DOCKETED	
Docket Number:	19-BSTD-03
Project Title:	2022 Energy Code Pre-Rulemaking
TN #:	236165
Document Title:	Guttmann & Blaevoet Consulting Engineers Dec 8th workshop Comments
Description:	N/A
Filer:	System
Organization:	Guttmann & Blaevoet
Submitter Role:	Public
Submission Date:	12/24/2020 3:36:55 PM
Docketed Date:	12/24/2020

**Guttman & Blaevoet Consulting Engineers Dec 8th workshop
Comments**

Guttman & Blaevoet Consulting Engineers Comments for 2022 Energy Code

TABLE G3.1.1A Baseline HVAC System Types

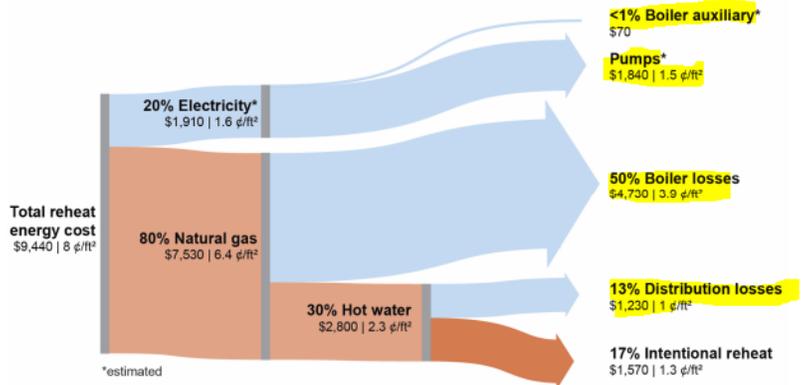
1. Heat pump baselines were considered for most occupancies but should be expanded for large schools and large offices.
2. All occupancies should have a fuel neutral option for domestic hot water – heat pump storage option.

3. All occupancies should that cannot have a reasonably cost-effective heat pump baseline should have an alternate fuel neutral option available in the CBECC-Com software to eliminate the penalty in the performance approach. There should be a prescriptively allowed fuel neutral baseline applied in the performance approach similar to what is allowed in ASHRAE 90.1-2010 standards. VRF/VRV are one of those particular system types that rarely can show compliance through the performance approach. The alignment to ASHRAE 90.1-2016 baselines have caused havoc in California and around the nation for electrification. We are calling on ASHRAE and the CEC to take a step back and reinstate a fuel neutral baseline for those occupancies where a single high efficiency heat pump baseline is not currently cost effective, either due to modeling capability or current time of use rate structures.
